Service Letter No: SL-200-082712

SUBJECT: Hydraulic cylinder (hub cap) screws

MODELS AFFECTED: **200RV, RV10 and 200A CONSTANT SPEED PROPELLERS
MANUFACTURED BETWEEN 05/03/2012 and 08/27/2012**

OLD STYLE
ROUND MOUNTING FLANGE

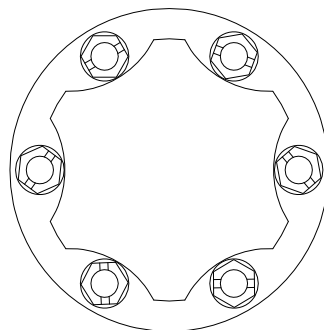
**DESCRIPTION OF
REQUIRED
CORRECTIVE
ACTION:** If the propeller has the "old" style round mounting flange **NO FURTHER
ACTION IS REQUIRED.**

NEW STYLE
HEXAGONAL MOUNTING FLANGE

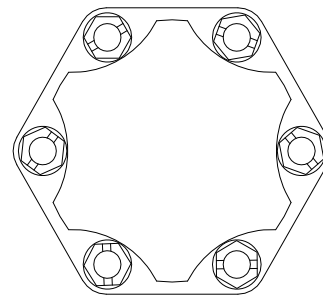
REASON: Propeller assemblies that use the 2012 "new" style 215 hub: The (14) hydraulic cylinder (hub cap) fastener holes are not tapped deep enough to allow the fasteners to be properly tightened. As such there is a possibility that the screws will crack or break over time.

If the propeller has the "new" style hexagonal mounting flange contact Whirl Wind Aviation for a no cost correction kit that contains (14) flat washers and a tube of #242 Loctite.

Working on one screw a time, each of the (14) hydraulic cylinder (hub cap) #10-24 socket head cap screws must be removed, the kit flat washer installed under the screw head, Loctite applied and then reinstalled in the propeller hub. Tightened to 25 in. lbs.
